Reply to Reviewers

Reviewer 1

Reviewer 2

Figure S1: Path of the optimization algorithm in the design space for the standard and soft-soft configurations.

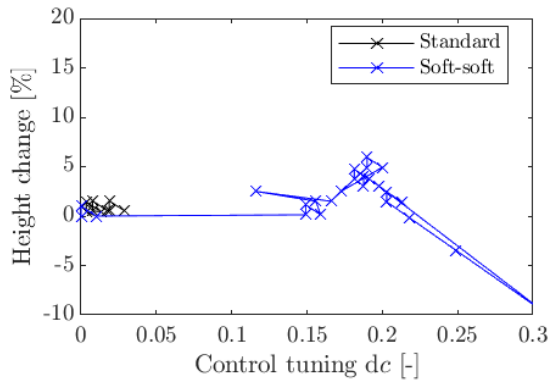
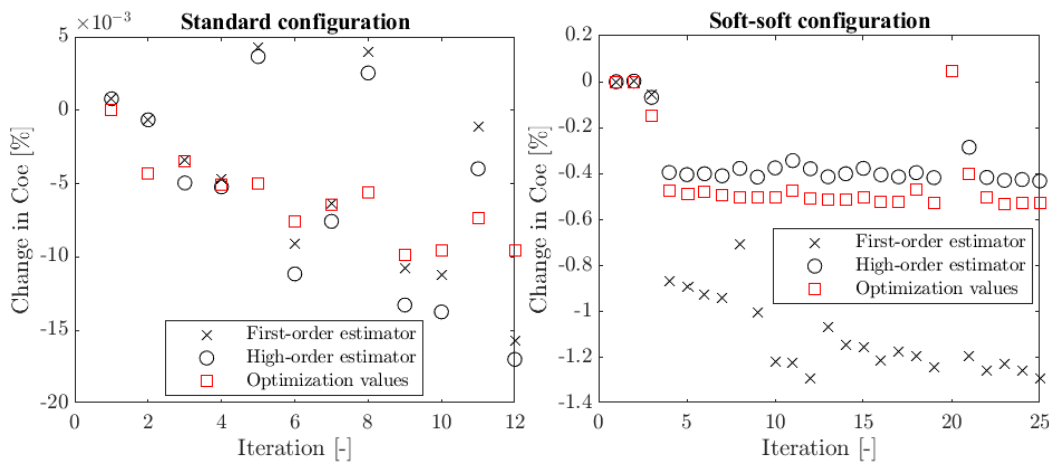
Figure 6 is very illuminating. It would be good to add such a figure as well for the first-order approximation, so that the difference between the two approximations becomes clearer. Furthermore, the full CCD problem will have given rise to a decent number of LCOE-evaluations and would allow to also visualize the actual underlying LCOE-surface for both tower types. It would be of great value if this were done, as it would give a feeling how far or close the approximations (+surrogate) are from the 'ground truth'.

Authors: We agree with this comment. We have updated Figure 6 to include the first-order estimate function and corresponding estimated optimum. In addition, Table 2 is updated to include the results for the first-order estimation.

Regarding the validity of the CoE estimate functions, the two CCD optimizations evaluate the CoE 12 and 25 times for the standard and soft-soft configurations, respectively. The value of the tower height and control tuning for these iterations is highlighted in Figure S1 below. However, it would be difficult to construct an accurate CoE surface from these point distributions. Instead, we compare in Figure S2 below the value of the CoE calculated during the optimization and the value of the first-order and high-order estimate functions at the same points. Both estimators capture the order of magnitude of the CoE, however the high-order estimator is much more precise. In order to keep the article concise, these figures have not been included in the revised manuscript.

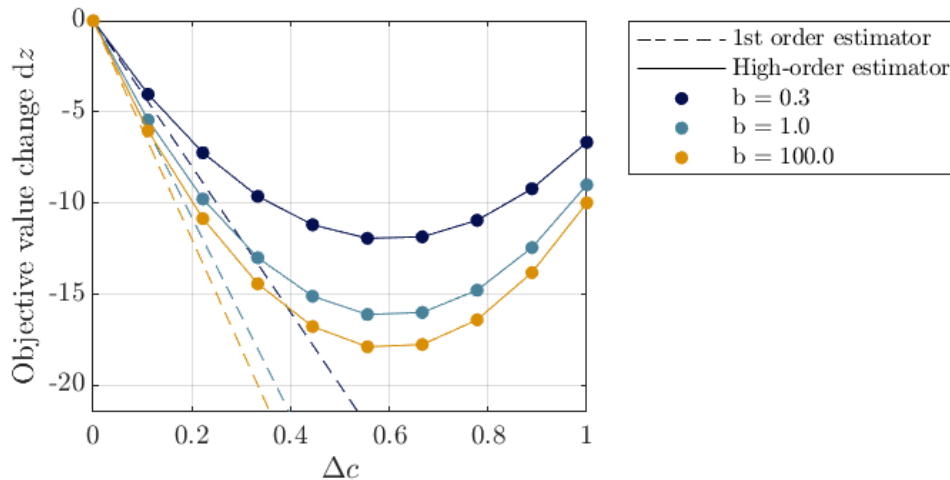
Authors: The notation $\Delta f(dc)$ is defined explicitly in the next line.
- p17|349-350: “we assume that the constraints that do not depend on x contribute marginally to the change of optimum”: is this a reasonable assumption (justify)

Authors: Upon further examination of the explanation of this validity assumption, it was found that it is not necessary for the high-order estimator and the corresponding proof. This is because the following equation (noted B6 in the manuscript) is valid for all active constraints, and not only active constraints that depend on c :

$$\nabla_x g_i(x^*, c_r)^T dx^* = -\Delta g_i(dc) + o(|dc|^2)$$

The relative contribution of the constraints to the change of optimum is reflected in the Lagrange multipliers. In the submitted manuscript, we included an example in Appendix C showing the impact of this validity assumption. However, the presented results were obtained with an error in the calculation of the high-estimator. Figure S3 presents the updated results, showing that the assumption has no impact on the precision of the high-order estimator. As such, we have removed this assumption in the updated manuscript.
